Congress St, Stevens Ave & Westgate Plaza

PLANNING BOARD

AMENDMENT TO CONDITIONAL USE AND SITE PLAN APPROVAL

Portland Planning Board
Portland, Maine
August 12, 2008 Public Hearing

REVISED LANDSCAPE PLAN

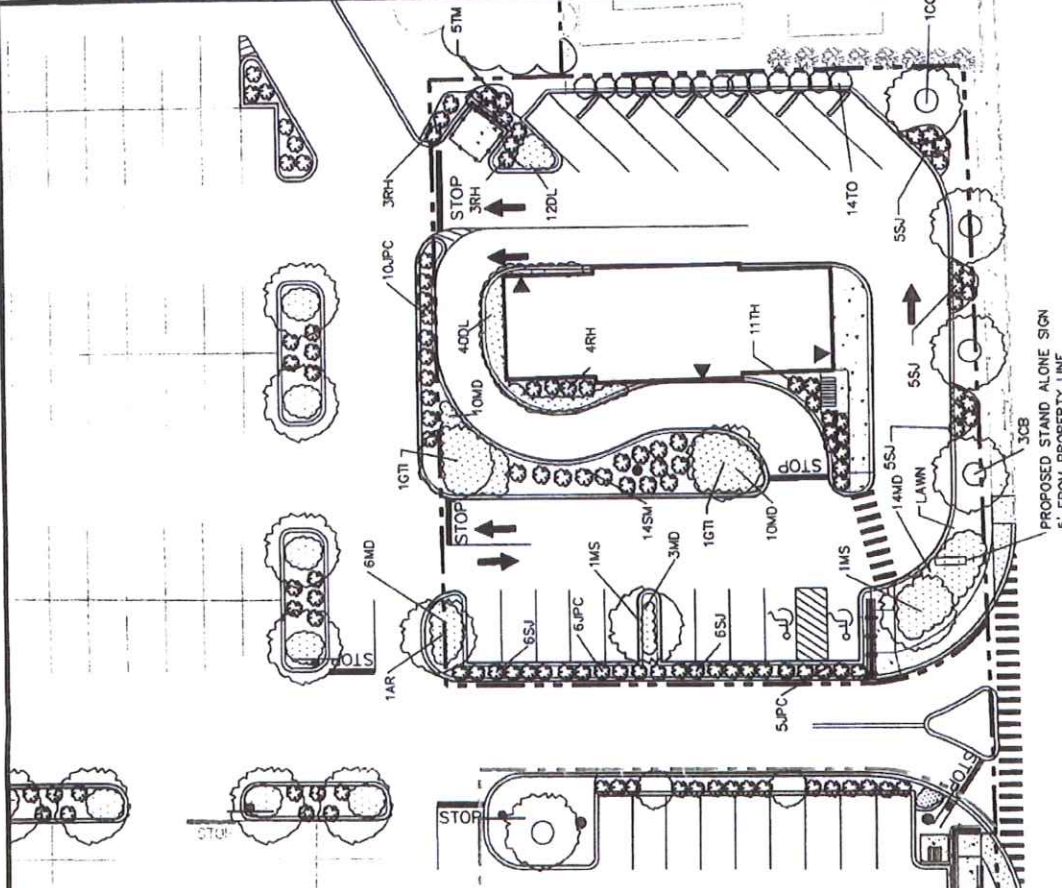
Jeff Tarling has reviewed the revised landscape plan and approves of the substitution of hicks upright yew for Russian cypress in order to screen headlight glare from vehicles accessing the drive-through window on the north side of the building from residences across Congress Street.

to the final site plan to be located on the west end of the line of emerald green arborvitae proposed along the southerly boundary of the site (as shown on the plan labeled 'Revised Landscape Plan. Proposed Restaurant. Congress Street. Portland, ME', dated August 8, 2008, which is attached).

24" x 24" FRAME & GREASE TRAP COVER (TP 2)
 Secondary piping (w/tee) for 8" SDP-35 PIPE WITH 8" HOLE FOR 88 BOOTS (TP 2)

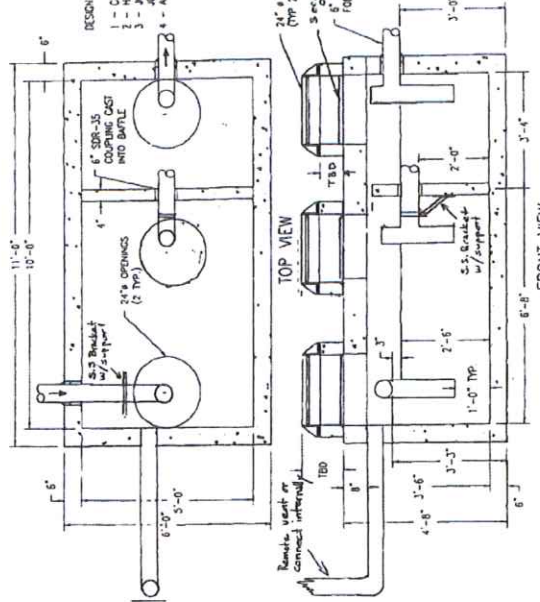
Steven Harris, Assistant Engineer has reviewed and approved the proposed grease trap as shown on the submitted detail drawing.

The applicant shall revise the final site plans to include a grease trap, including adequate information concerning location, specifications and related sewer utility connection details. This plan shall be reviewed and approved by the Department of Public Services prior to the issuance of a building permit.
